MFN 06-274

Subject: Response to RAI Letter Number 20 Related to ESBWR Design Certification Application – Seismic Design – RAI Numbers 3.7-16, 3.7-24, 3.7-27, 3.7-30, 3.7-32, 3.7-33, 3.7-35, 3.7-37, 3.7-38, 3.7-39, 3.7-50, 3.7-54 and 3.7-57

**Response to NRC RAI Letter No. 20 Related to ESBWR Design
Certification Application**

**RAI Numbers 3.7-16, 3.7-24, 3.7-27, 3.7-30, 3.7-32, 3.7-33,
3.7-35, 3.7-37, 3.7-38, 3.7-39, 3.7-50, 3.7-54, and 3.7-57**

Figure 7.4-1 Lateral Soil Pressure - RBFB R1 and F3 Wall

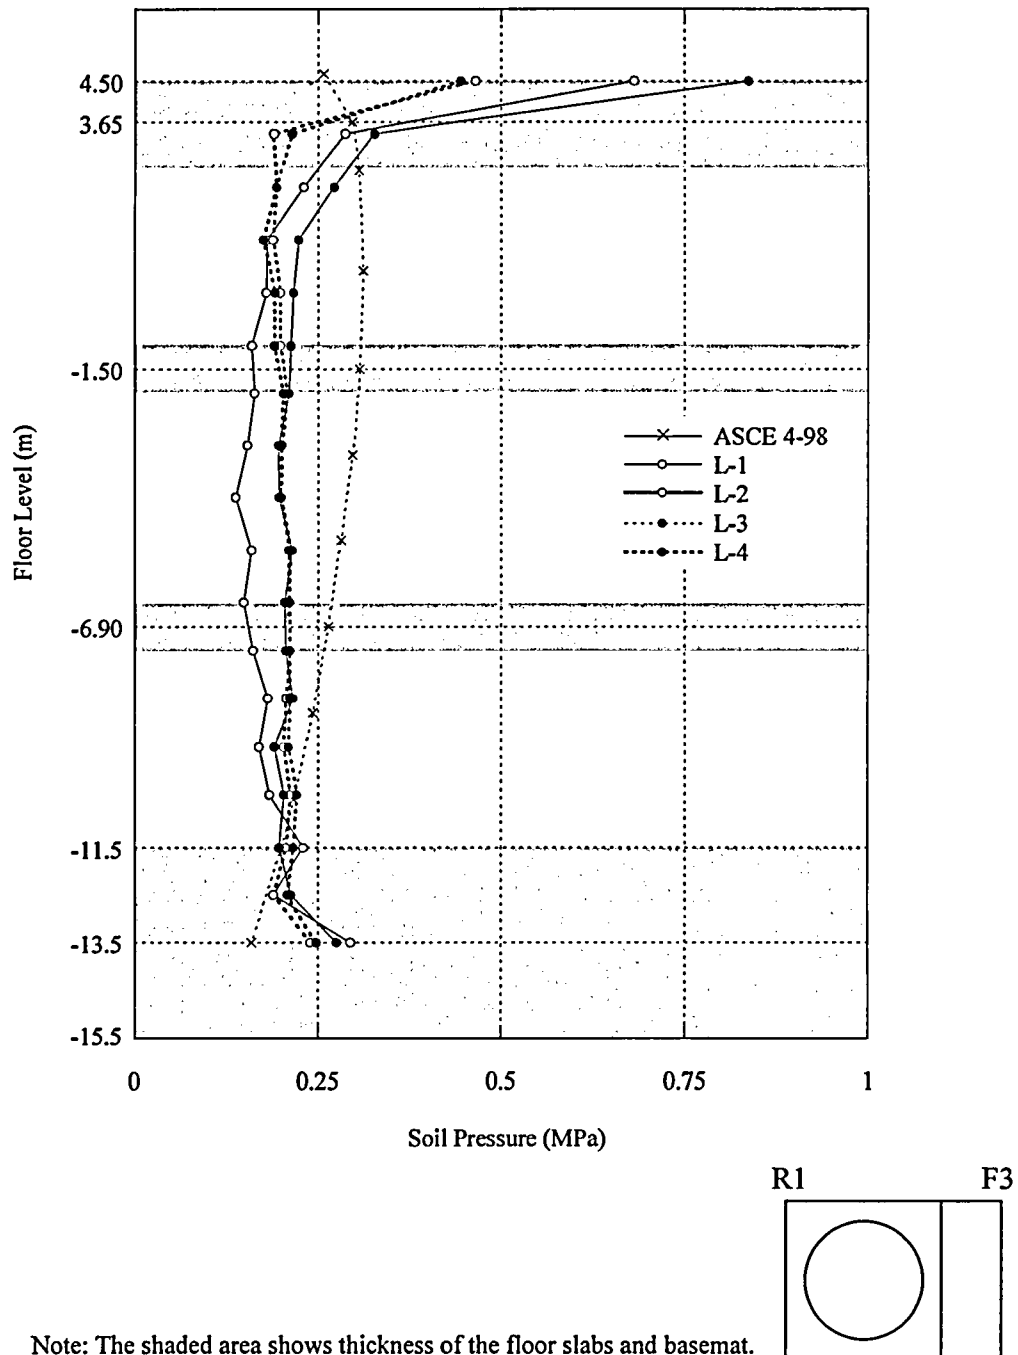
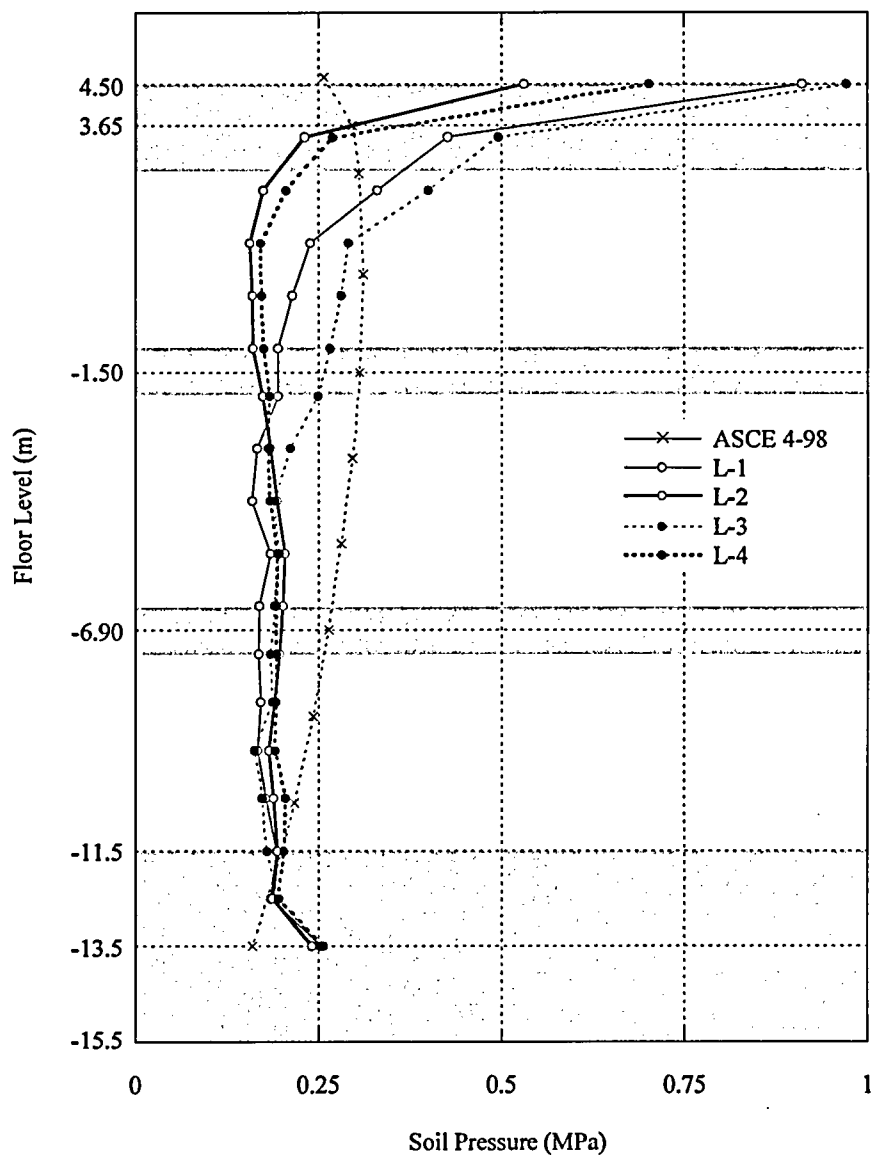
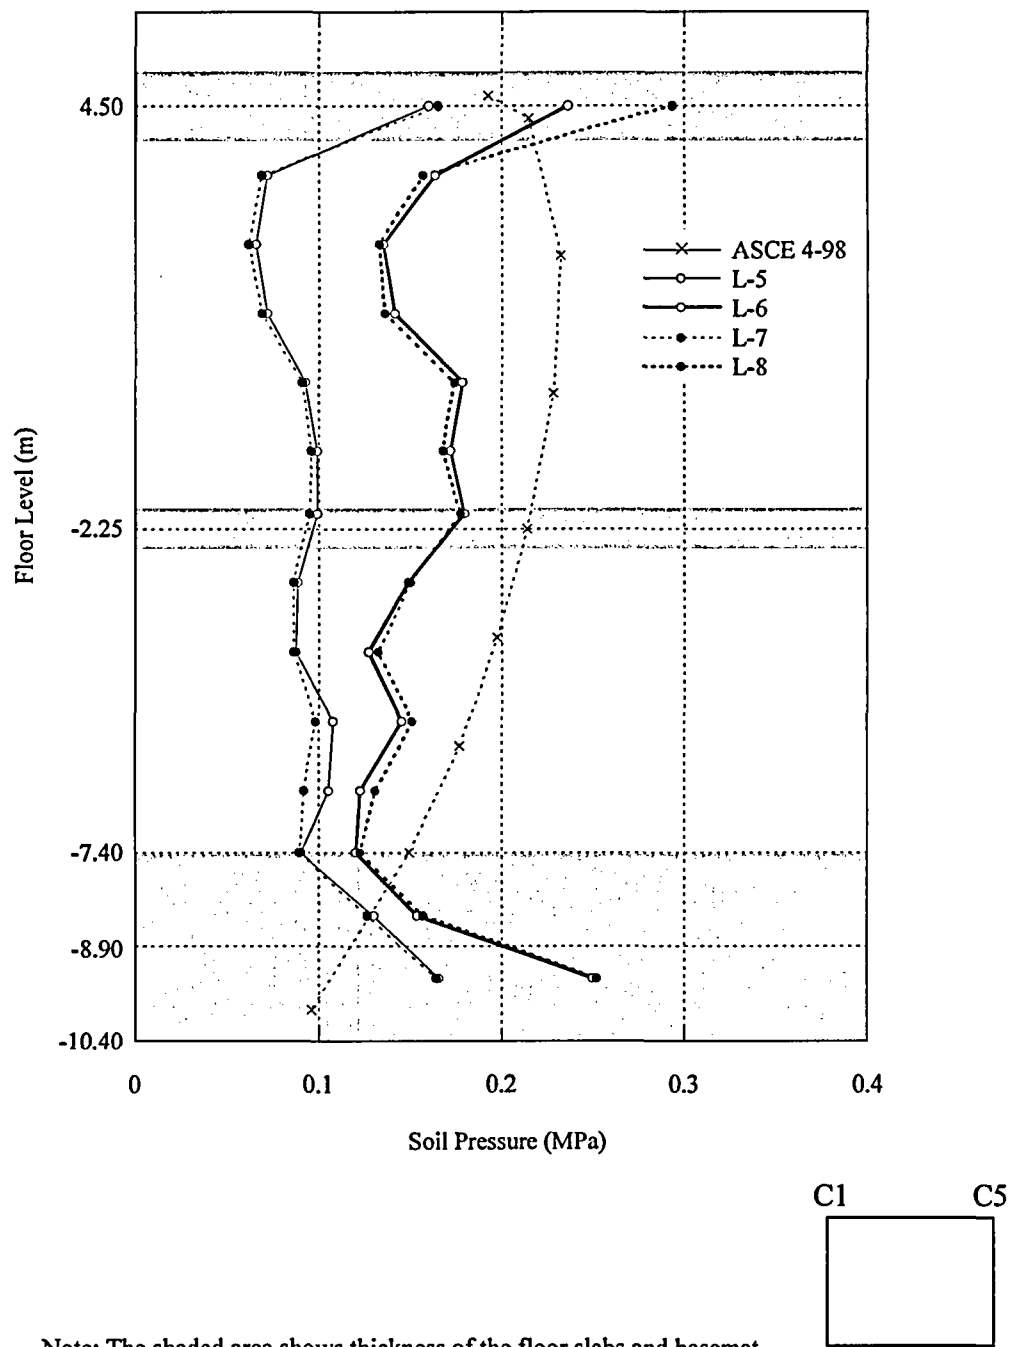
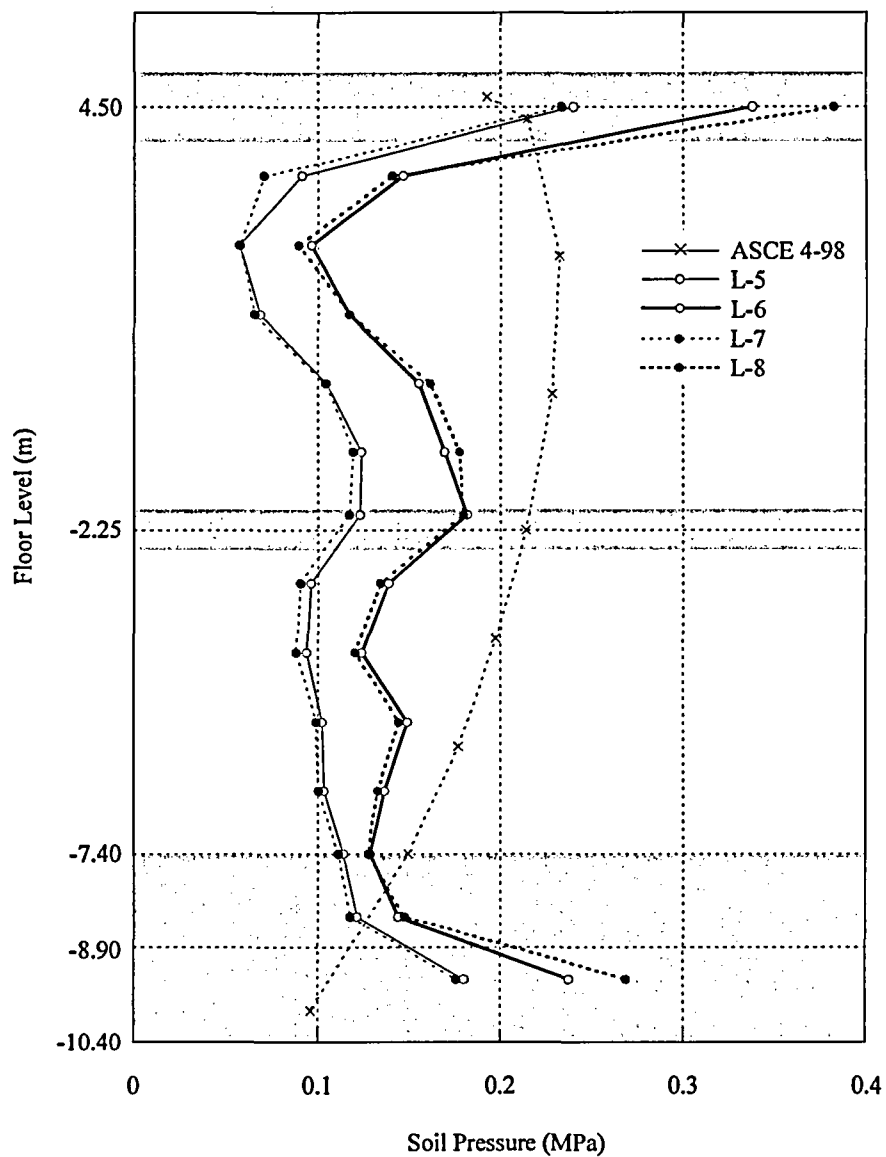
DCD Section 3A.5 indicates that the use of lateral pressures computed from the equivalent static pressure analysis listed in ASCE 4-98 is conservative. Based on reviews of a number of facilities, it is known that actual pressures computed from detailed SSI evaluations of embedded foundations are directly influenced by the characteristics of the foundation response spectrum used to define the ground motions as well as the relative stiffness (shear wave velocity) of the soils above the basemat level. The staff requests the applicant clearly indicate in the DCD either (1) the technical basis for the statement that these static pressures are conservative for any site, or (2) any limitations that need to be incorporated into the acceptable site profile characteristics to limit the actual dynamic pressures anticipated.

In the existing DCD, the lateral pressure computed from the equivalent static pressure analysis listed in ASCE 4-98 is used for the design soil pressure. To confirm the ASCE 4-98 method is conservative, the soil pressures calculated from the SASSI analysis for the layered sites described in Section 7.2 was compared with the ASCE 4-98 method soil pressures in Figures 7.4-1 through 7.4-4.

It is found from the results that the SASSI soil pressures are generally bounded by the ASCE 4-98 soil pressures; however, at the elevation close to the ground surface and the basemat elevation, the SASSI soil pressure exceeds the ASCE 4-98 soil pressure. The design soil pressure loads for the exterior walls are calculated by averaging soil pressures which each wall is subjected to. The calculated design soil pressures are summarized in Tables 7.4-1 and 7.4-2, comparing between the SASSI soil pressures and the ASCE 4-98 soil pressures. The envelope of the two values will be used for the exterior wall design.

Figure 7.5-1 Floor Response Spectra - RBFB Basemat X

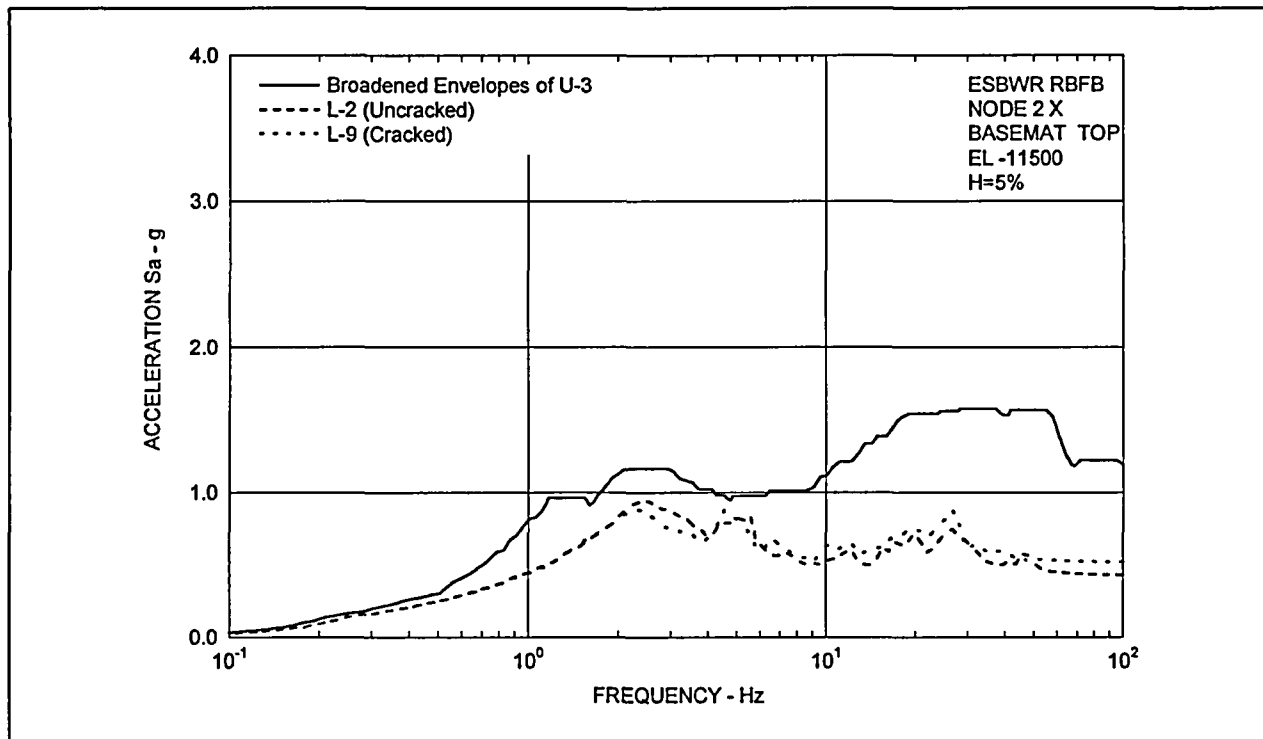
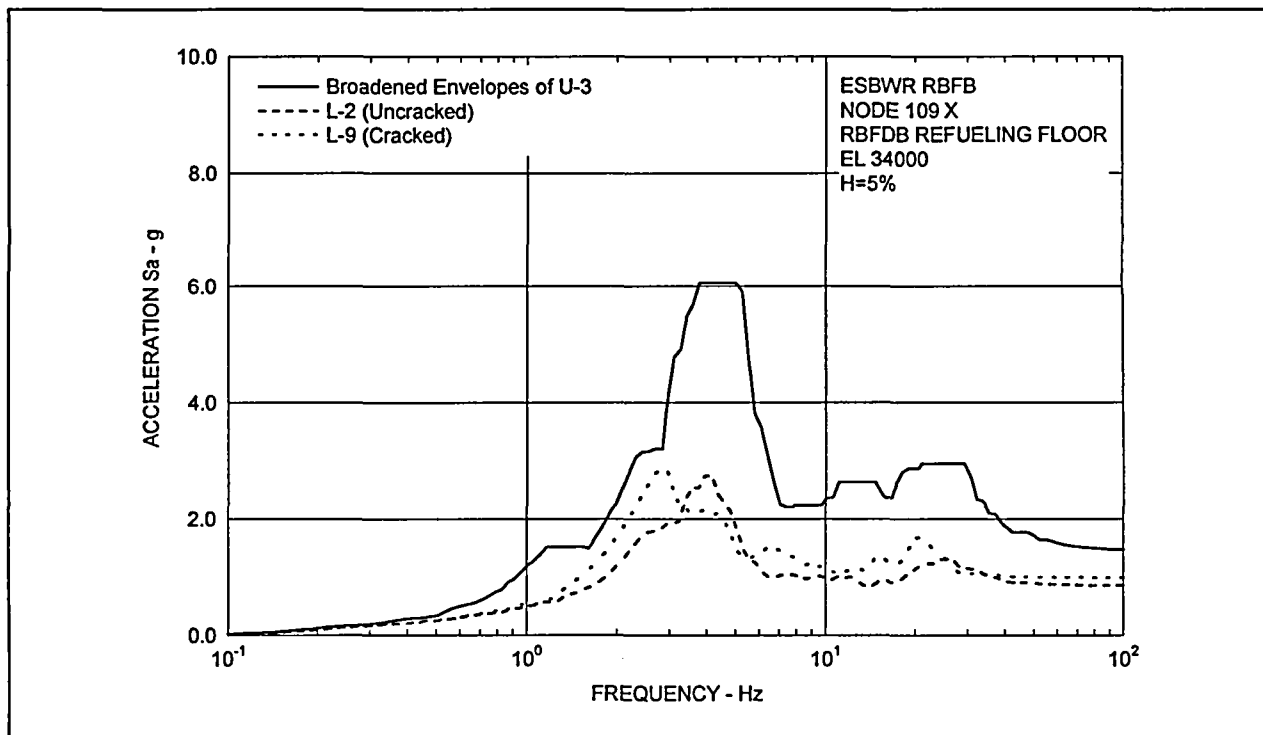
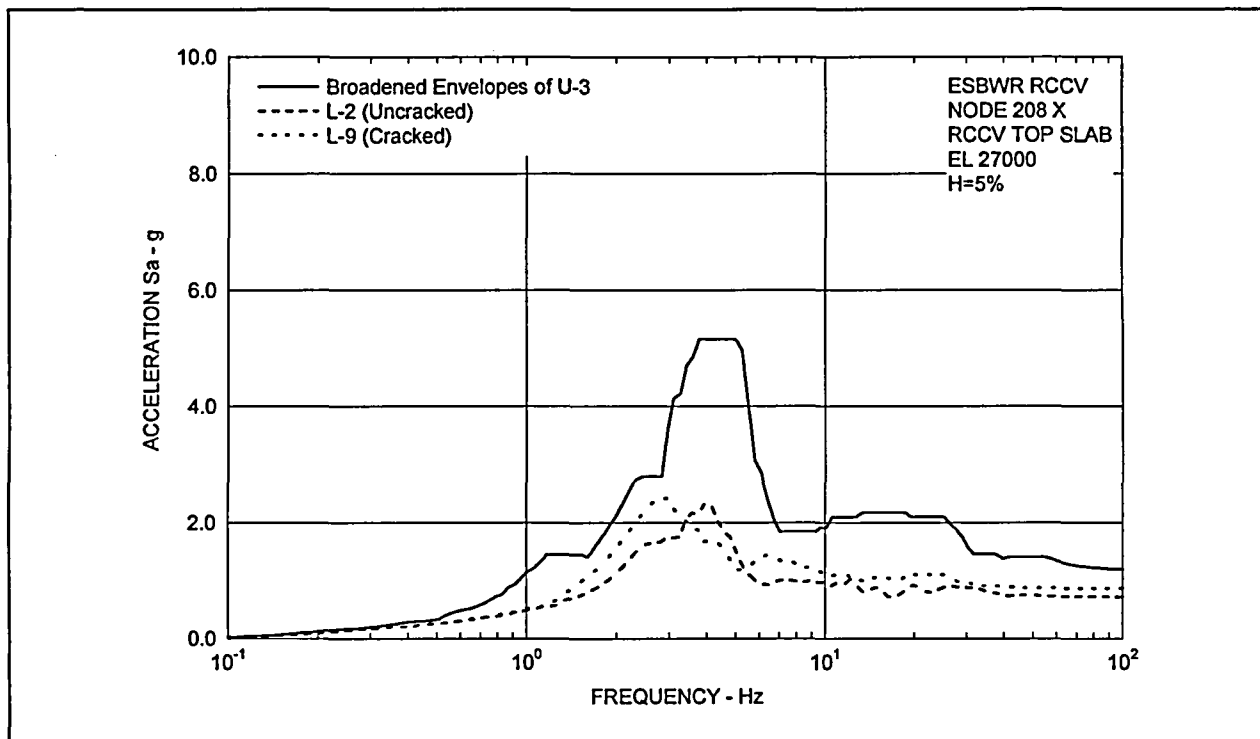
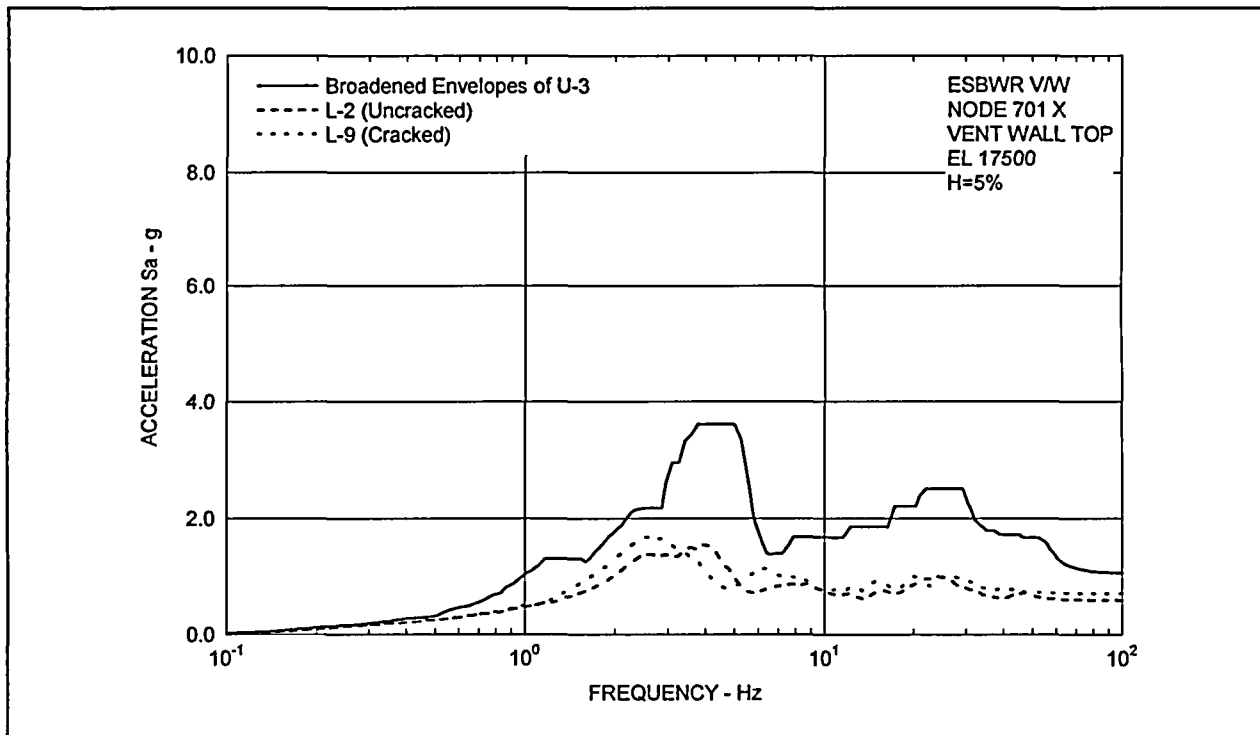
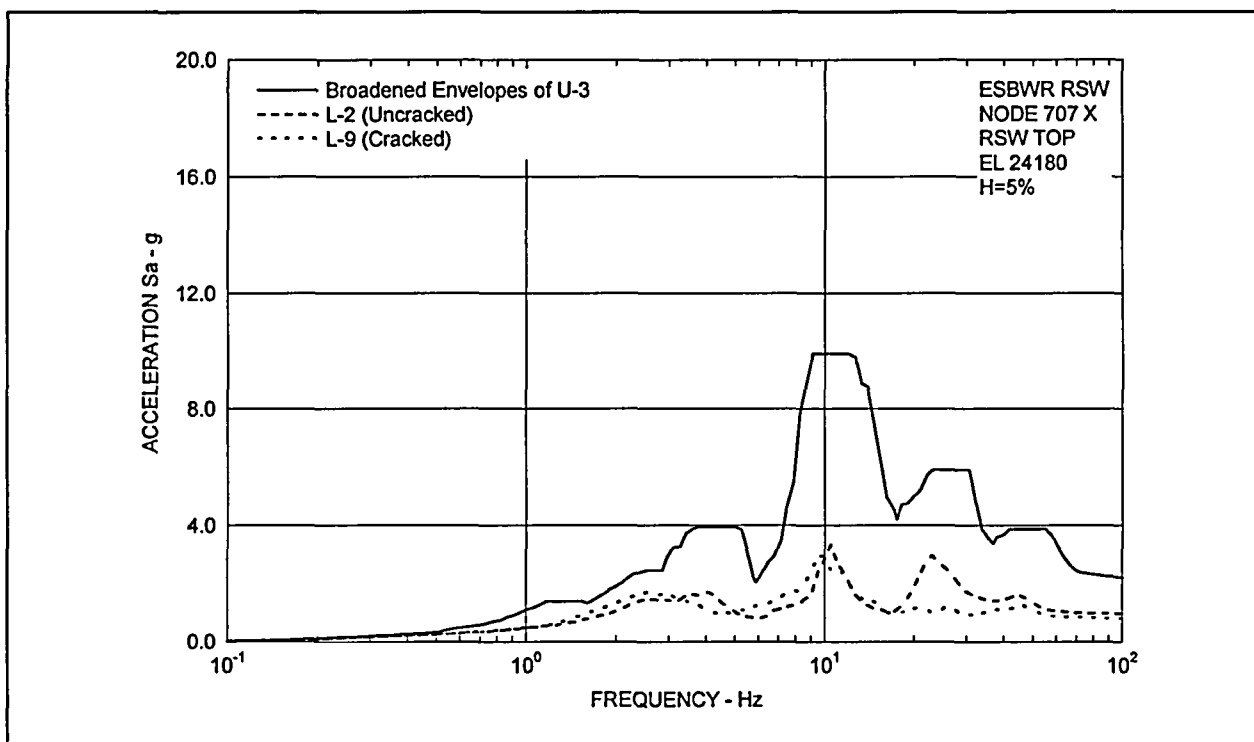
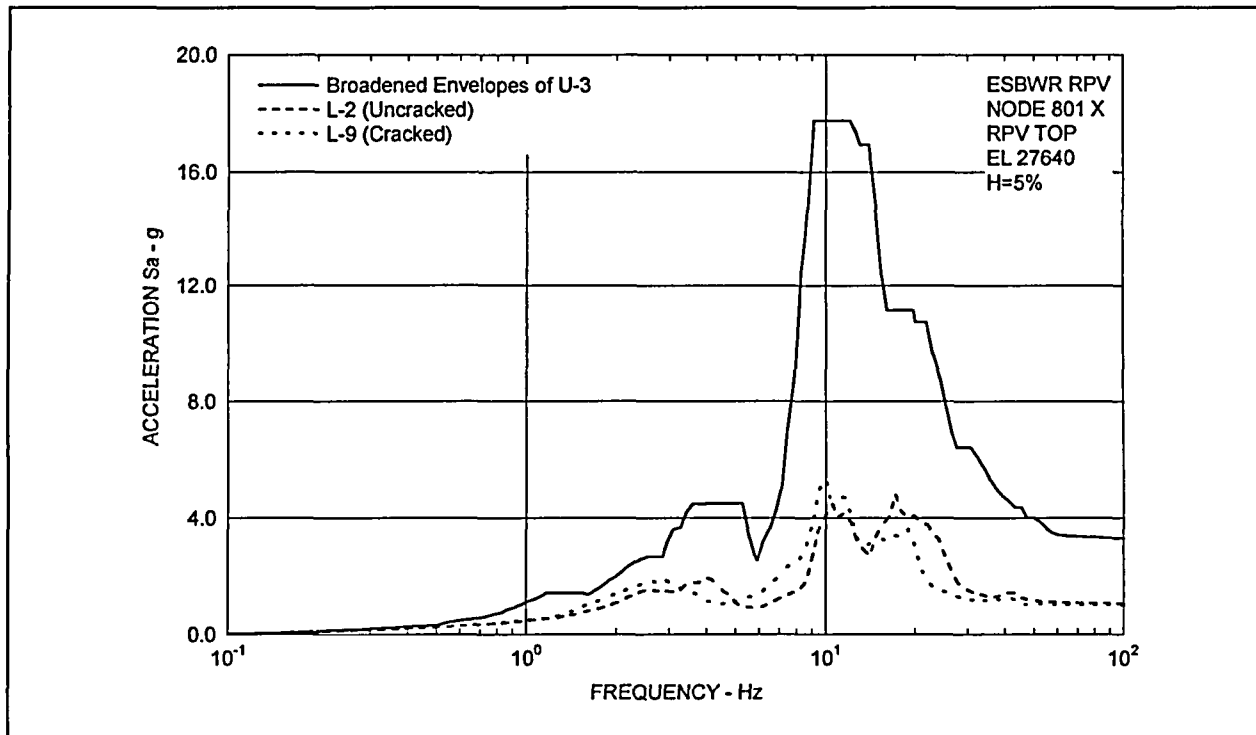
DCD Section 3.7.2.3, "Procedures Used for Analytical Modeling," does not address the method used to develop stiffness values (uncracked concrete sections versus cracked concrete sections) for concrete structural elements for the seismic analysis models. The staff requests the applicant include in the DCD a detailed description of the method applied to determine the stiffness values for both cracked concrete sections and uncracked concrete sections in the seismic analysis models.

Comparisons of floor response spectra (FRS) (5% damping) at selected RBFB locations are shown in Figures 7.5-1 through 7.5-12. The broadened envelope results of Case U-3 (uniform site, single envelope input motion case) are also shown in the figures for comparison.

It is found from the results that the FRS peaks move to lower frequencies by concrete cracking; however, both FRSs of uncracked and cracked cases are bounded by the broadened envelope responses of uniform site cases in the whole frequency range.

As stated in Section 7.1, the existing DCD design load will be updated to incorporate the responses due to the single envelope input motion at the uniform sites. The revised DCD design load has no impact from the effect of concrete cracking.
